Docket Number:	24-OPT-04
Project Title:	Potentia-Viridi Battery Energy Storage System
TN #:	264183
Document Title:	CEC Data Request #2 - Alternatives Response
Description:	N/A
Filer:	Ronelle Candia
Organization:	Dudek
Submitter Role:	Applicant Consultant
Submission Date:	6/11/2025 10:36:57 AM
Docketed Date:	6/11/2025

CEC Data Request – Alternatives Response

Potentia-Viridi Battery Energy Storage Project

Reduced Capacity Alternative Conceptual Site Plan

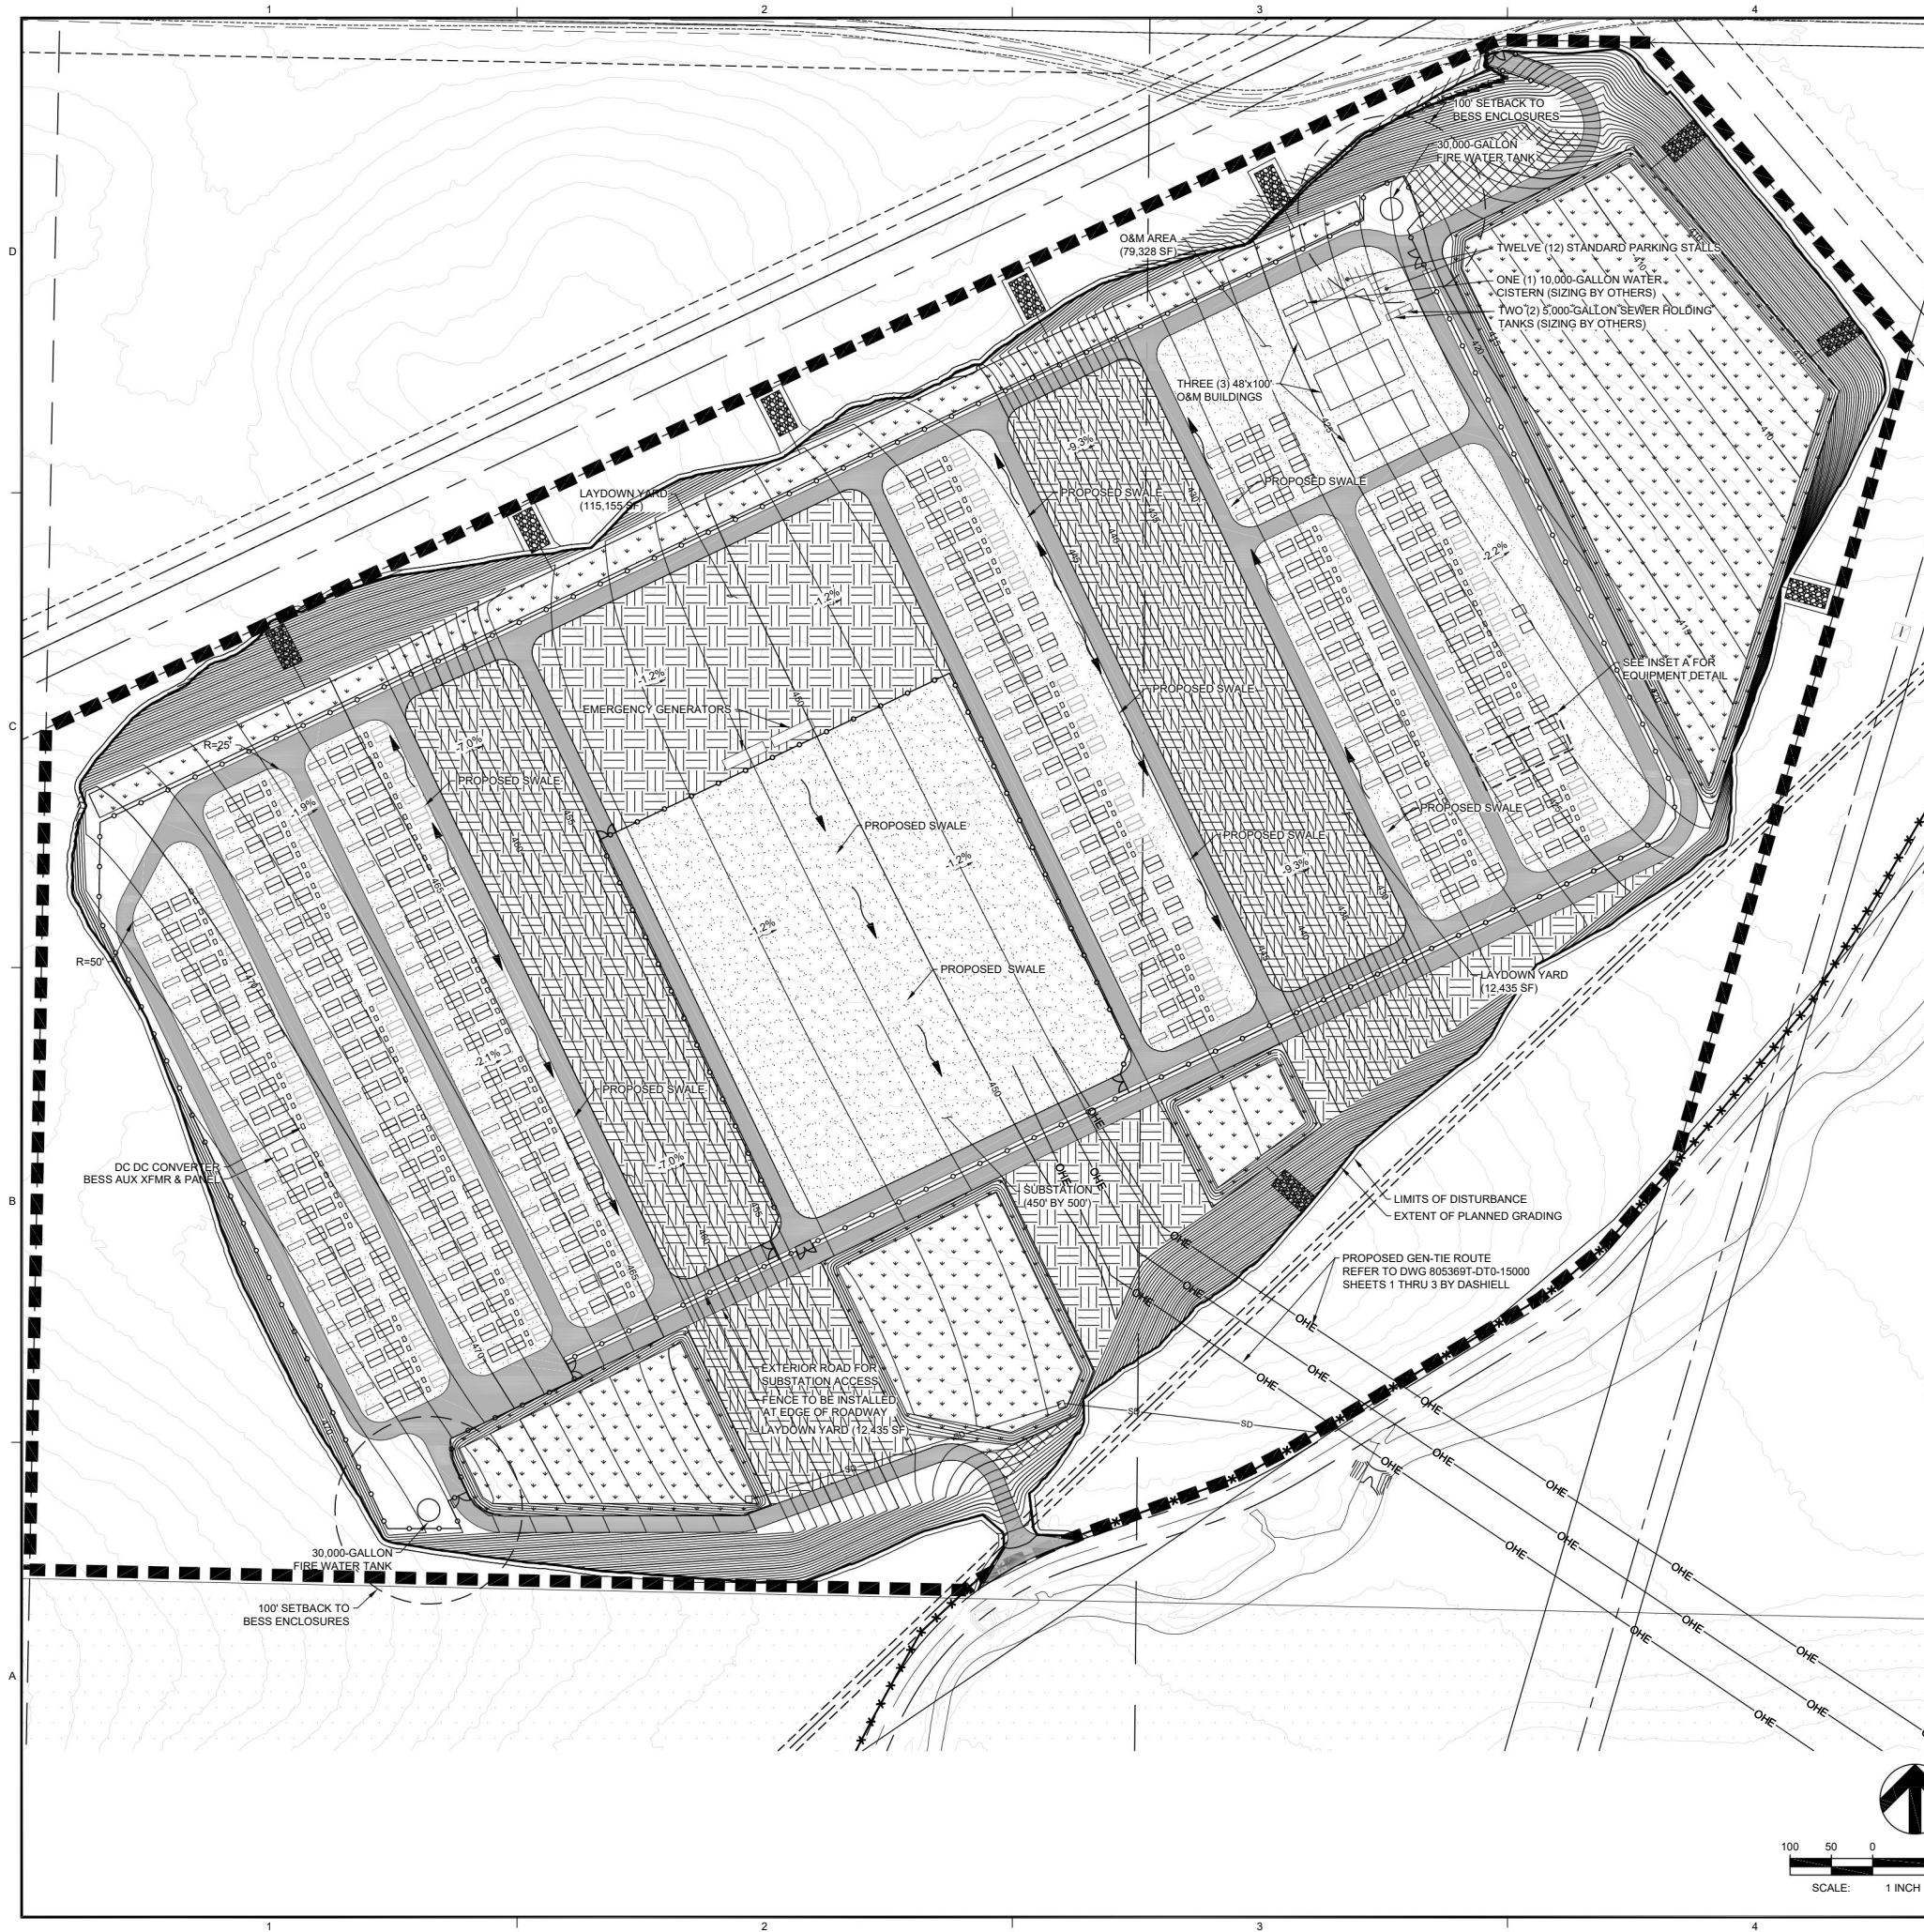
REV 1 DR ALT-1. *Please provide a figure that displays a conceptual site plan for the Reduced Project Alternative (i.e., staff's Reduced Capacity Alternative). This figure should be a large-scale, zoomed-in site map, that clearly shows estimated changes to the site plan for this alternative and revisions to the project site boundaries.*

Response: See Attachment 1 for the Alternative 2 (Reduced Capacity Alternative) conceptual site plan. The Alternative 2 battery energy storage system's (BESS) development footprint was originally identified as 40 acres in Section 4.7 of the application document. The development footprint has subsequently been revised to ensure that design elements that were incorporated into the Proposed Project site plan, many of which have been identified as participating agency requirements following feedback on the original application, are incorporated in the Alternative 2 conceptual site plan. These site changes include:

- Two (2) water tanks were added to the layout to meet requirements identified by the California Department of Forestry and Fire Protection.
- Additional stormwater facilities were added following grading refinements to the Proposed Project site plan that would also apply to Alternative 2.

- Additional access roads along the south side were added to increase site safety by allowing for separate substation access without requiring the entry into the main BESS facility, and additional space was needed between the double access roads for appropriate security fencing.

- Two (2) additional O&M buildings (for a total of three (3)) and additional required O&M area were added per potential BESS manufacturer's requirements.

- The substation area was expanded based on actual design parameters.
- Added additional laydown area(s) to allow for safe maintenance of BESS units through operations and augmentation throughout the project life.

- All above items resulted in an overall expanded footprint, which required additional benching/terracing to reduce earthwork quantities

Following the revisions of the Alternative 2 conceptual site plan the new BESS facility footprint is 55.8 acres (see Attachment 1). Implementation of Alternative 2 would not change the design of the project's gen-tie facility, so the temporary and permanent impacts associated with the Proposed Project gen-tie facility would also apply to Alternative 2. A comparative impact breakdown of the project facilities is provided below in the response to REV 1 DR ALT-2.
